Exhibit B
Response to COE Question 2

CLARIFICATION OF DISCHARGES

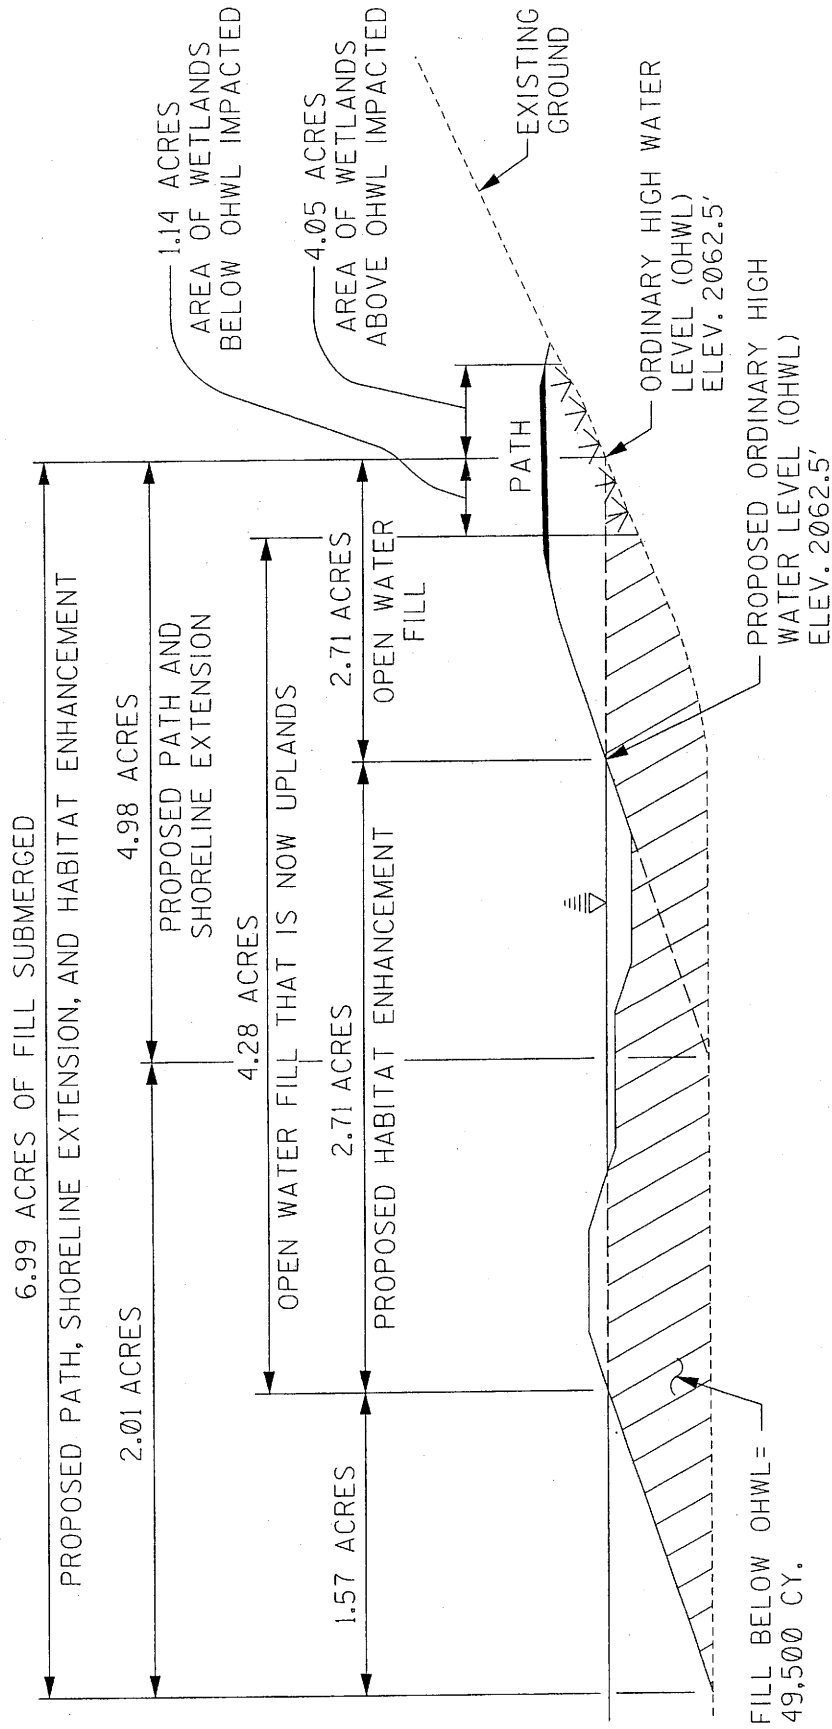
COE Comment 2(d)

"How do you propose to protect wetlands located adjacent to project construction areas from construction impacts?"

Response:

The Contractor shall provide 10 day notice before work begins in areas adjacent to wetlands as shown on the plans or flagged. The Engineer will flag the boundaries of the wetlands that are to remain untouched. The Contractor shall retain and protect the boundary flagging throughout construction, install construction fence around wetland areas, and shall not operate within the wetland boundary. If the Project Clearance Summary plan sheet identifies that this contract requires a NPDES Permit, the Department will include a preliminary (incomplete draft) NPDES Storm Water Pollution Prevention Plan (SWPPP) in the contract. The preliminary plan contains information about project site characteristics, drainage patterns, and known areas where pollution prevention and erosion control measures are needed. If a NPDES Permit becomes required because the Contractor increases the area of disturbance, preparation of the entire SWPPP will be performed by the Contractor. Completion of a SWPPP is a required as part of the permitting process any time a NPDES Permit is required. An Erosion and Sediment Control Plan (ESCP) will be required on all contracts that do not require a NPDES Permit. The ESCP shall include a Spill Prevention Plan and shall be submitted to the Engineer for review and approval prior to ground disturbing activities. The ITD has entered into a Consent Decree (the Decree) with the United States Environmental Protection Agency (EPA) regarding certain requirements for storm water management and pollution prevention on all ITD Projects subject to the Clean Water Act (CWA) NPDES storm water construction regulations at 40 C.F.R. § 122.26(b)(14)(x) or 40 C.F.R. § 122.26(b)(15). There are certain mandatory terms and conditions of the Decree that affect the Contractor's construction activities and obligations. The Contractor is responsible for compliance with all of these items and with all Contractor-based requirements from the Decree, as well as all other Contractor responsibilities noted in the Contract. The requirements listed in this provision are necessary to comply with the Decree, the CWA, and NPDES Permits. The Contractor shall present the required SWPPP information at the pre-construction conference. The Contractor shall provide detailed information about the intended sequence of work (including the initial site preparation work to install sediment basins, sediment traps, perimeter dikes, silt fencing, etc.), pollution control methods, locations of staging areas, stockpiles, and any other ground disturbing activities. This information will be reviewed, and in conjunction with information provided by the Department, compiled into a SWPPP. The SWPPP will be signed by the Department, the Contractor, and all subcontractors performing ground disturbing work identified in the plan. The Department and the Contractor must each complete a Notice of Intent (NOI) form. Once the SWPPP is approved, the Department and the Contractor will electronically file NOI's separately. No construction work of any kind will be performed until both

NOI's are posted on the EPA website and the seven day waiting period is over. Prior to initiating any Construction Activities, the Contractor shall designate a Water Pollution Control Manager (WPCM). Contact information including name, address, and telephone number for the WPCM shall be submitted to the Engineer. The WPCM shall have attended storm water management training, presented by a third party and approved by the Department, in the twelve months prior to the beginning of Construction Activities on this Contract. The WPCM shall be responsible for ensuring compliance with the Clean Water Act.
